Access Compliance Report

Public Rights-of-Way

Intersection ID: 11201	Main Street: BRIARHILL_DR	Cross Street: MEADOWCLIFF_DR	Location:	N
ADA ID: 7F13FB8F1D55	Ramp Type: BlendTrans1	Initial Pass/Fail: Fail	Overall Compliance: No	Severity Score: 10

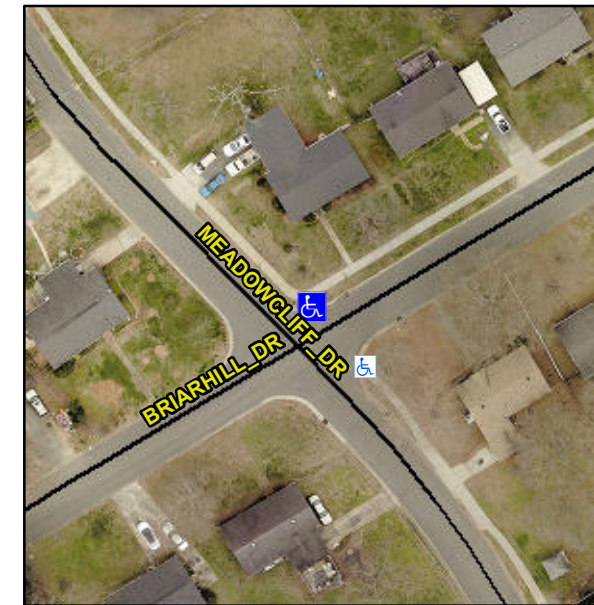
Surveyor Notes:

N/A

Not Found, R304.5.1, R304.5.3

Remove & Replace Curb Ramp With Two New Directional Ramps or Equivalent.
